DUKE POWER COMPANY

OCONEE NUCLEAR STATION, UNIT NO. 1

AMENDMENT TO FACILITY OPERATING LICENSE

Amendment No. 71
License No. DPR-38

Figure 3.1.2-1A

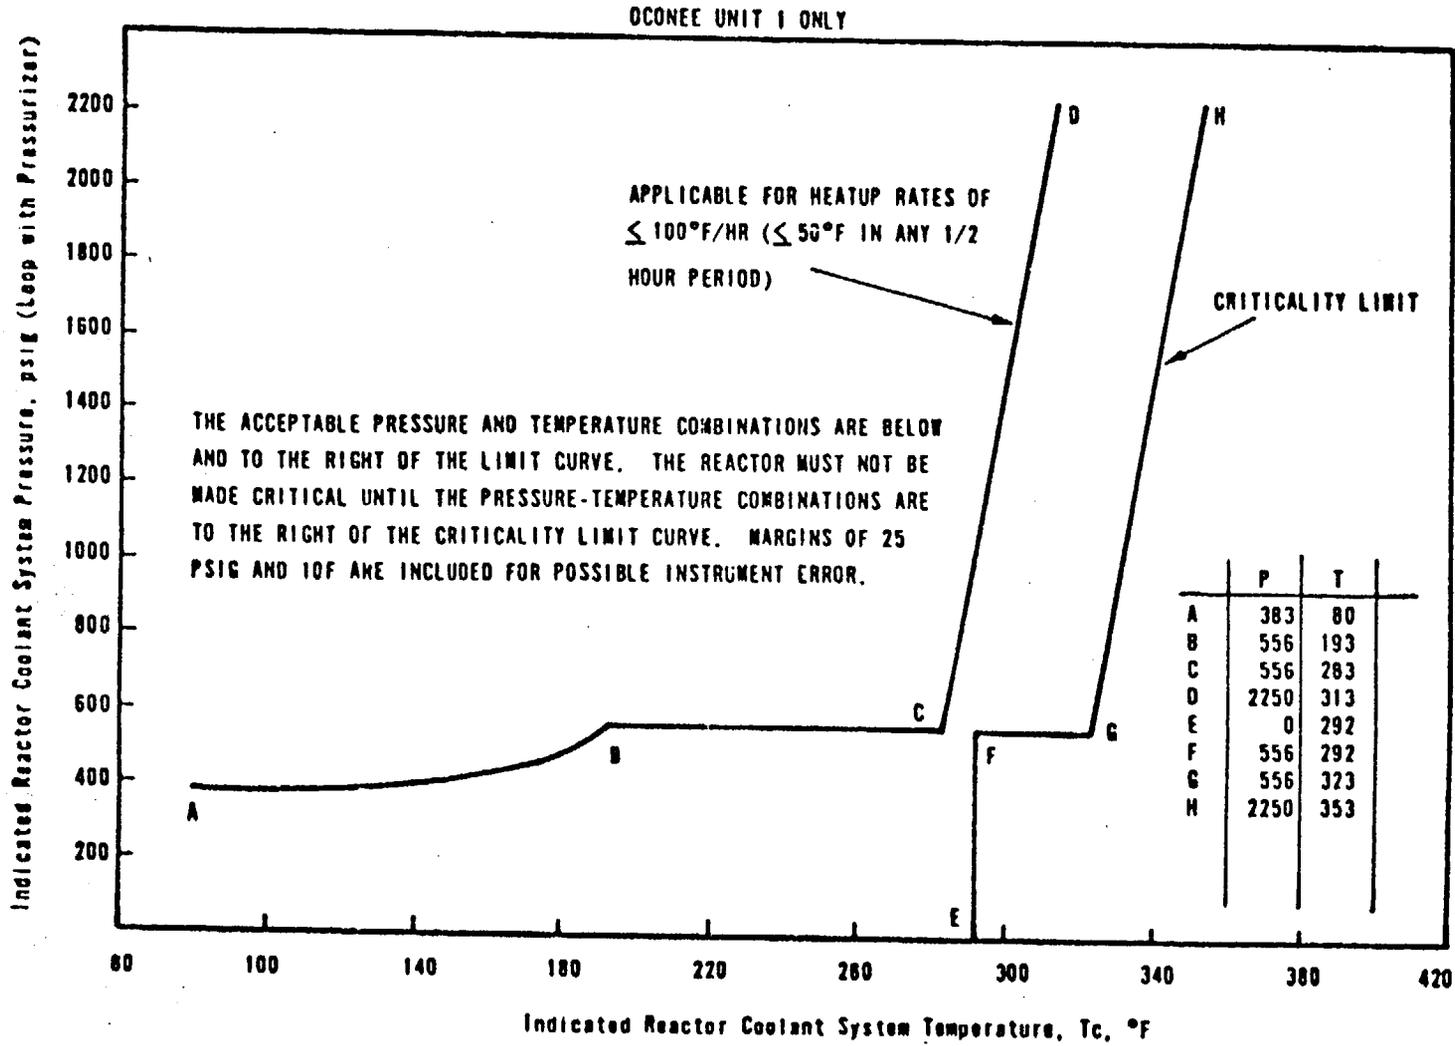
REACTOR COOLANT SYSTEM
 NORMAL OPERATION-HEATUP LIMITATIONS APPLICABLE FOR FIRST 6.0 EFFECTIVE FULL POWER YEARS

UNIT 1
 OCONEE NUCLEAR STATION

We conclude that the proposed pressure-temperature operating limits and changes to Technical Specification 3.1.2 are acceptable but only through 6 EFPY instead of 8 EFPY as proposed by DPC. DPC has agreed to this change. For this operating period the proposed pressure-temperature operating limits are in accordance with the fracture toughness requirements of Appendix G, 10 CFR Part 50. Compliance with Appendix G in establishing safe operating limitations will ensure adequate safety margins during operation, testing, maintenance and postulated accident conditions and constitute an acceptable basis for satisfying the requirements of NRC General Design Criterion 31, Appendix A, 10 CFR Part 50.

Figure 3.1.2-2A

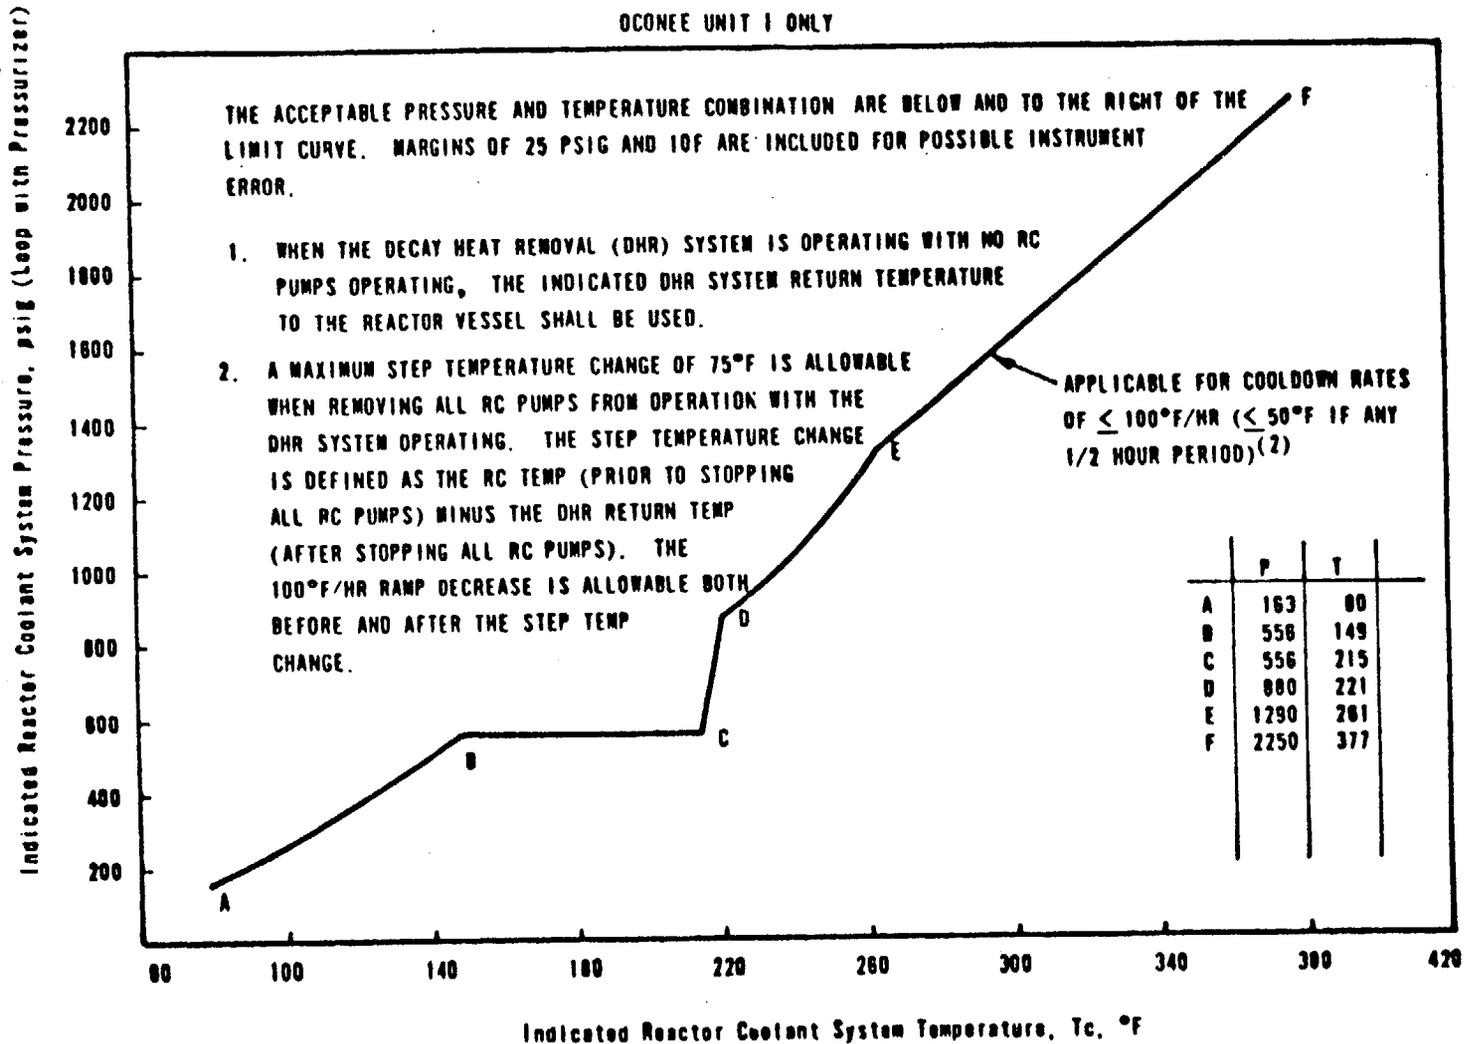
REACTOR COOLANT SYSTEM
 NORMAL OPERATION-COOLDOWN
 LIMITATIONS APPLICABLE FOR
 FIRST 6.0 EFFECTIVE FULL
 POWER YEARS UNIT 1
 OCONEE NUCLEAR STATION

Figure 3.1.2-3A

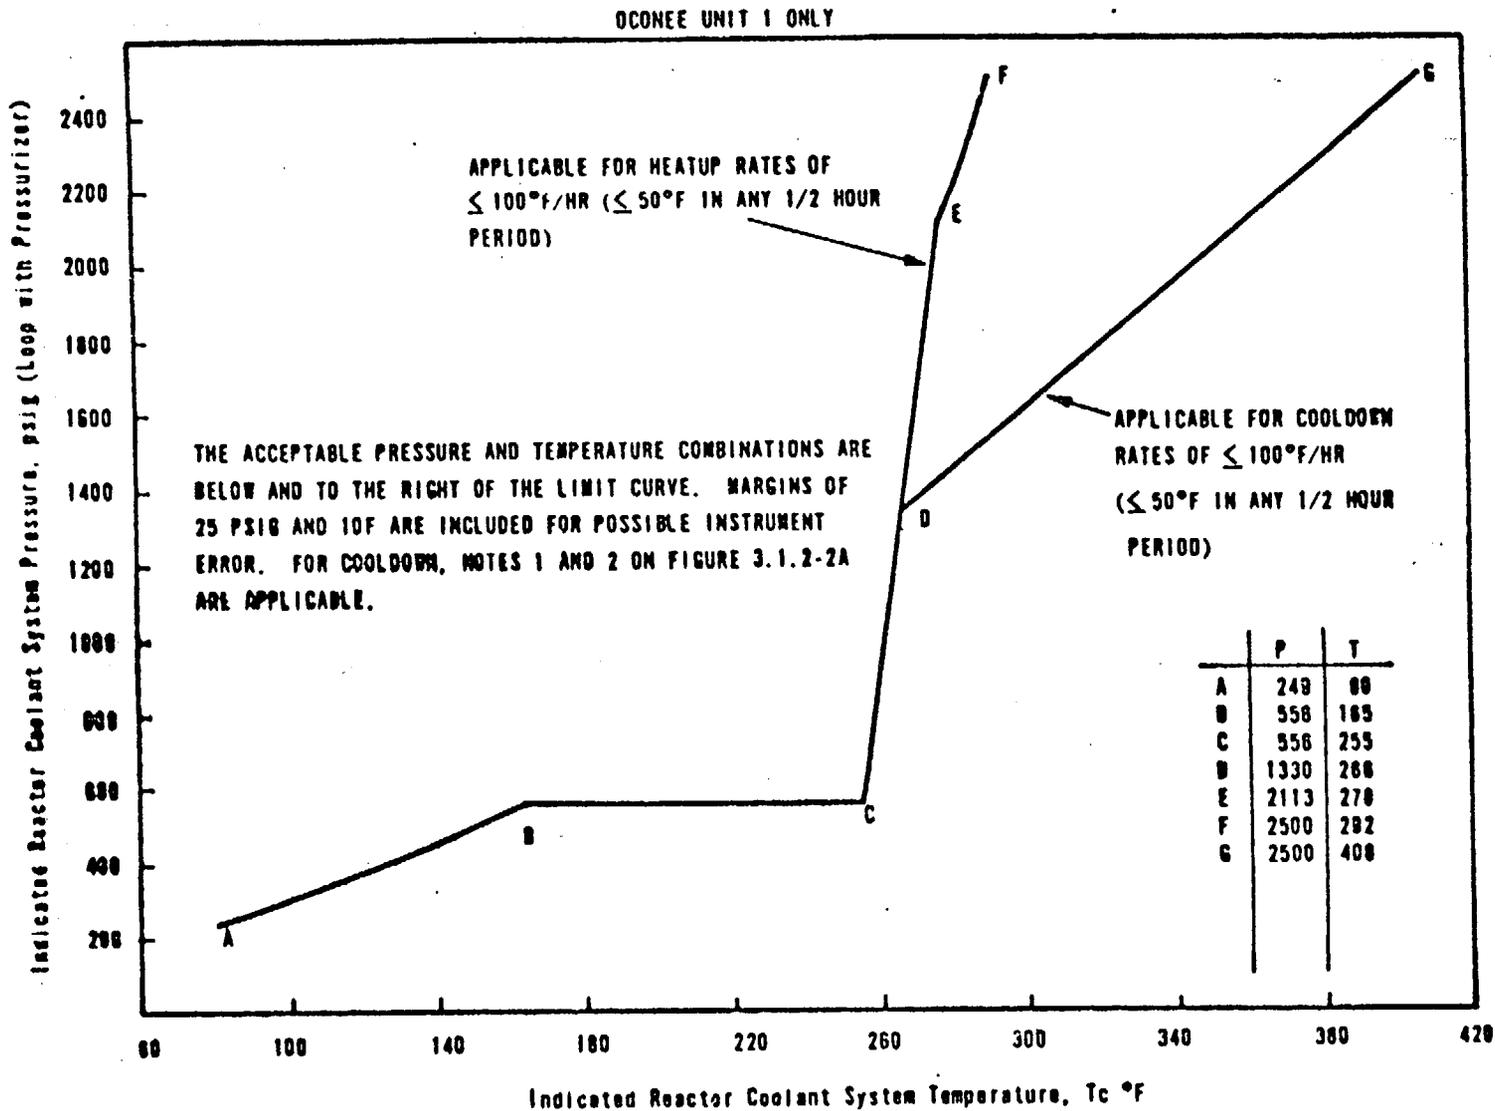
REACTOR COOLANT SYSTEM
 INSERVICE LEAK AND HYDRO-
 STATIC TEST HEATUP AND
 COOLDOWN LIMITATION
 APPLICABLE FOR FIRST 6.0
 EFFECTIVE FULL POWER YEARS
 OCONEE NUCLEAR STATION
 UNIT 1
